Application of Friends of St. Patrick's Episcopal Day )  
School LLC pursuant to 11 DCMR § 3104.1 for a Special )  
Exception for a Theoretical Lot Subdivision and a Private ) No. 17429  
Middle and High School in the R-1-B District at Premises )  
1801 Foxhall Road, N.W. (Square 1346, Lots 825, 826, )  
and 827). )  
\_\_\_\_\_ )

**REQUEST FOR PARTY STATUS**

**Response to Comments of Friends of St. Patrick's School  
Regarding the Alternate Development Plans of the  
Colony Hill Traffic and Access Subcommittee**

Diagram 2: Relocation of  
Foxhall/Whitehaven intersection  
for longer stacking lane for  
southbound Foxhall traffic

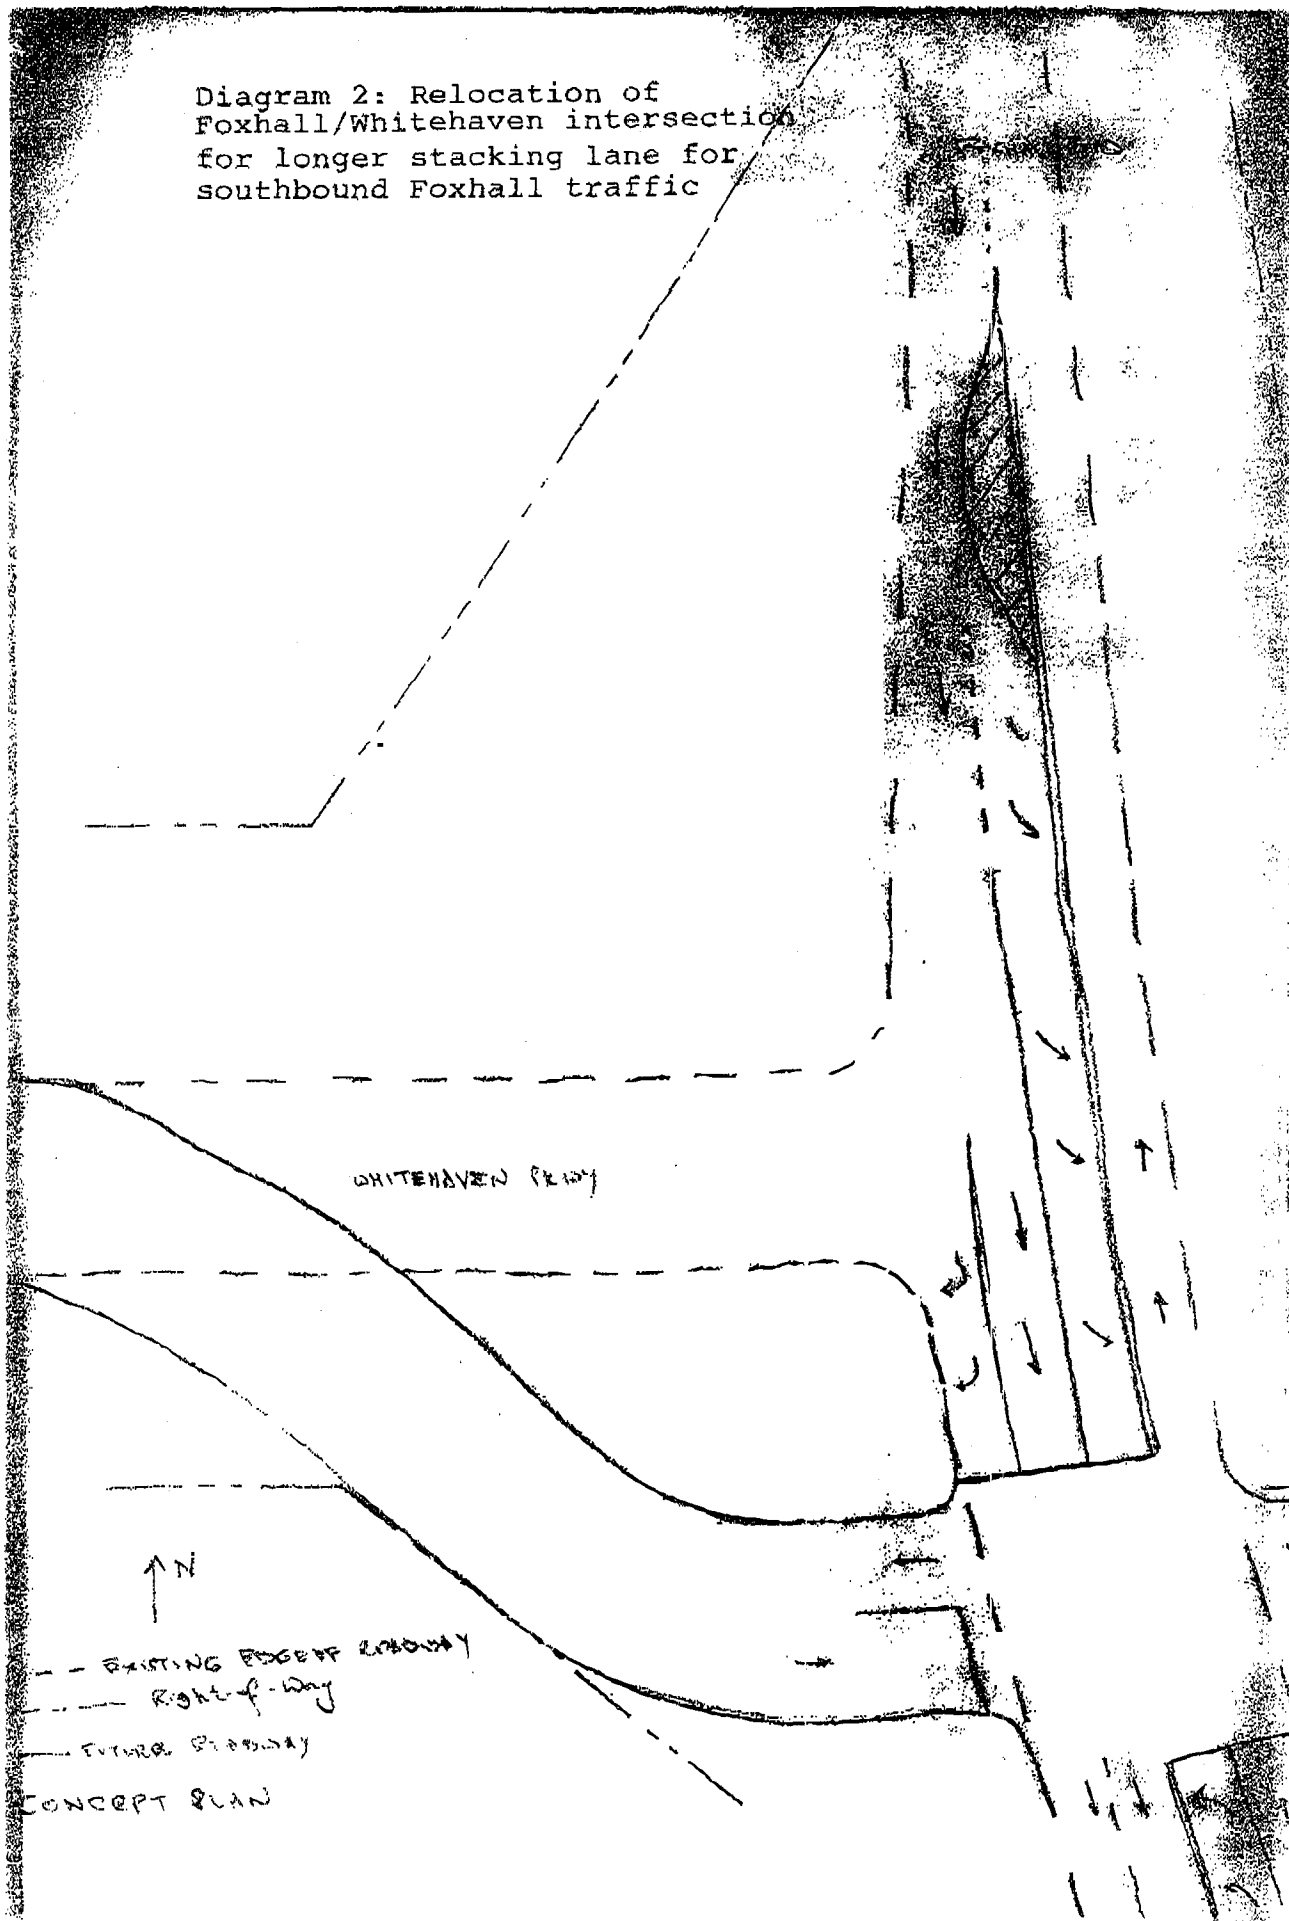
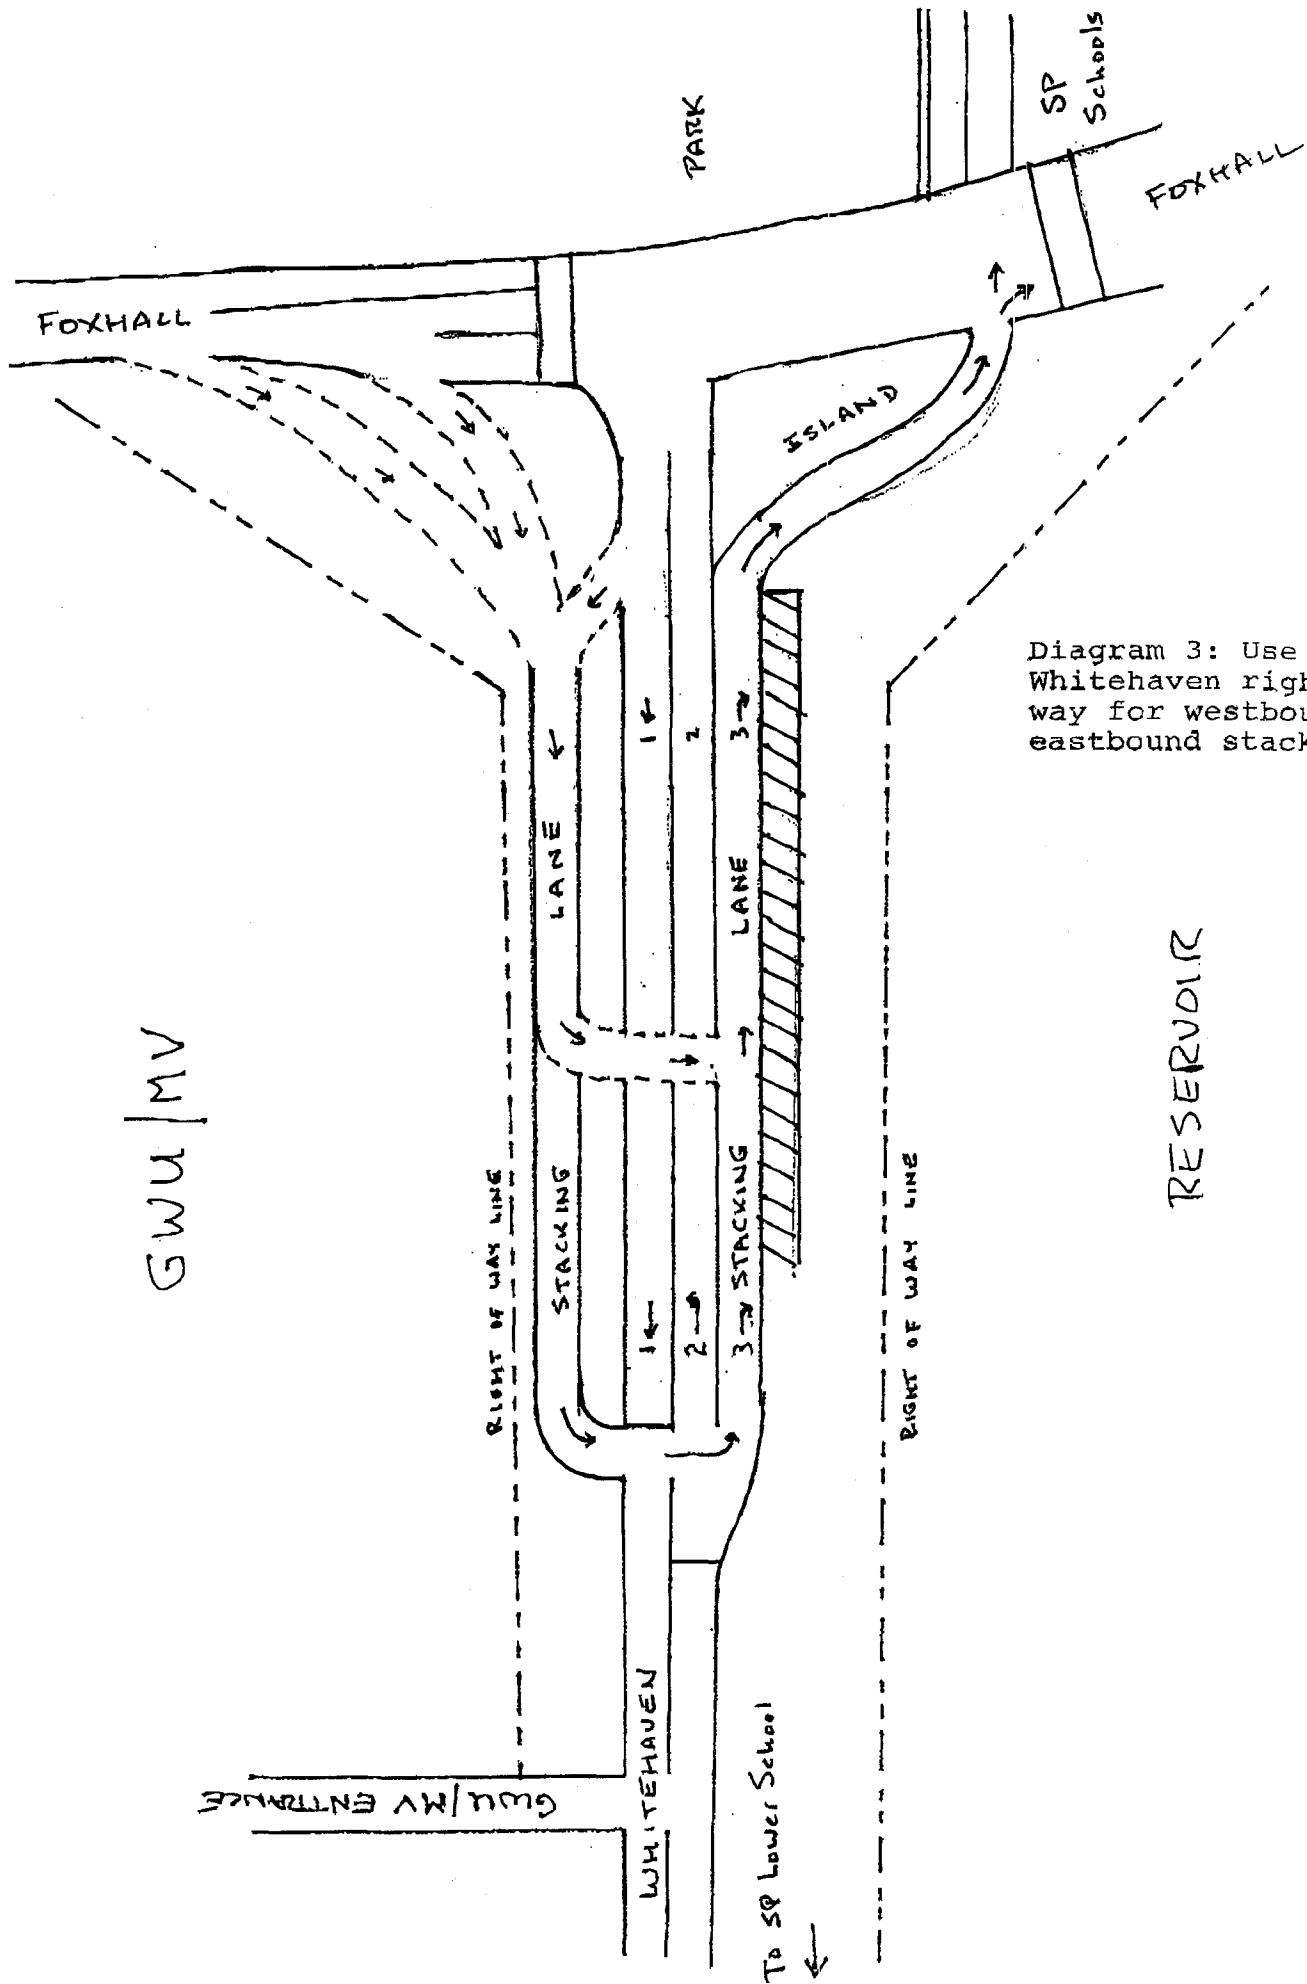
*This new road would then neither align with the School Property nor create a long enough southbound left-turn lane to provide adequate stacking room for motorists turning left off Foxhall Road into the School Property.*

*The south side sidewalk is the main pedestrian connection between the existing Lower School and Chapel and the proposed middle/high school campus. Under the [Subcommittee alternative plan], all pedestrian traffic would have to cross Whitehaven Parkway somewhere west of this intersection and cross back over southward again somewhere further east, perhaps within the new School Property. This would be inconvenient at best and both dangerous for pedestrians and cause traffic delays, at worse, especially at peak drop-off and collection times. The FOSP Access Plan, which places the new School entrance across from the German Embassy, avoids these problems by separating the middle/high school vehicular traffic from the pedestrian traffic at the Whitehaven Parkway intersection.*

*There is currently diagonal public parking on the south side of Whitehaven Parkway, which was installed by St. Patrick's. While not required to meet the lower school's parking requirement, it is nonetheless a vital part of the successful traffic management plan currently in place at St. Patrick's. At least 100 feet, or some 15 diagonal spaces would be lost due to the [Subcommittee's...] road realignment. Currently, this parking is only restricted [sic] for St. Patrick's use during school hours and is used by teachers, administrators, parent volunteers, and visiting parents. After school hours the general public, including the German Embassy, and visitors to GW, are free to use the space. Therefore, eliminating these spaces will push more parkers into the community.*

*The southbound turn lane on Foxhall Road to the north of the proposed light is similar in length to the one shown in the FOSP Access Plan, but it is located in the portion of Foxhall Road that is narrowed to only one single, unobstructed southbound lane. In the unlikely event that the turn lane was full, another car planning to turn left would bring all southbound traffic to a standstill. In the FOSP Access Plan, however, the proposed left-turn lane is located at a section of Foxhall Road that is four lanes across. Therefore, in the FOSP Access Plan, the [stet*

*Northbound traffic slowing and turning into the [Subcommittee's...] new entrance into the middle/high school campus also impedes and potentially stops all northbound traffic in a similar way, because there is only one northbound lane at this point as well. Once again, this vulnerability does not exist in the FOSP Access Plan, which constructs the northbound right-turn lane into the middle/high school campus on the section of Foxhall Road that is four lanes across, thereby leaving the remaining two northbound lanes unobstructed.*

By our measurements, the nearest (underground) part of the Reservoir is approximately 70 feet – not 60 feet - south of the existing Whitehaven Parkway. Upon reflection, however, we agree that the roadbed could move only about 40 feet to the south of the existing Parkway. We have therefore prepared a Revised Diagram 2 showing this alignment. In this revised diagram, the "S" curve has been eliminated and a simple re-alignment of Whitehaven has been accomplished to move the road southward 40 feet at the point where it meets Foxhall Road.

The intersection would also provide more than adequate stacking room for southbound traffic seeking to turn left into the School Property. This could be done by re-angling the existing lanes to the northeast, creating a third lane on Foxhall north of Whitehaven Park, and taking advantage of a generous right of way shoulder on the east side of Foxhall. The western-most lane would continue southbound for through traffic at Whitehaven Parkway. The middle lane would become a southbound stacking lane for left-turn traffic into the School. The eastern lane would be for northbound through traffic. Please see Revised Diagram 2. This three-lane arrangement could be extended northward to accommodate a stacking lane of 10 or more automobiles before Foxhall reverts to being a single lane northbound and a single lane southbound. In no instance would land in Whitehaven Park be affected. Land a short distance further north on Foxhall would be affected, but only within the currently designated right of way.

As shown in Revised Diagram 2, a new pedestrian crossing of Foxhall Road would be installed at the southern edge of the new Whitehaven/Foxhall intersection. Individuals wishing to go from the Saint Patrick's middle/upper school to the lower school would use a path south and west of SP's proposed Administration Building to get to this crossing. Once across Foxhall, they would utilize a metal or wooden ramp structure to go around a tree immediately west of the sidewalk and would proceed from there to the existing sidewalk down to the lower school.

As seen in the Subcommittee's Revised Diagram 2, some of the referenced parking spaces would indeed be eliminated in realigning Whitehaven southward by 40 feet as it intersects Foxhall. Those spaces and many more, however, would be established on the northern side of Whitehaven opposite many of the existing spaces.

For the Subcommittee's alternative plan, this problem is overcome in Revised Diagram 2 by creating a new entering lane on the east side of Foxhall Road south of the revised Whitehaven/Foxhall intersection. The existing right-of-way in this area would permit not only such an additional lane, but also continuation of the sidewalk currently proposed for the east side of Foxhall in this area. Alternatively, the sidewalk could stop at the planned pedestrian entrance/exit to the upper/middle schools. None of the planned buildings of these schools would be affected by these suggestions.
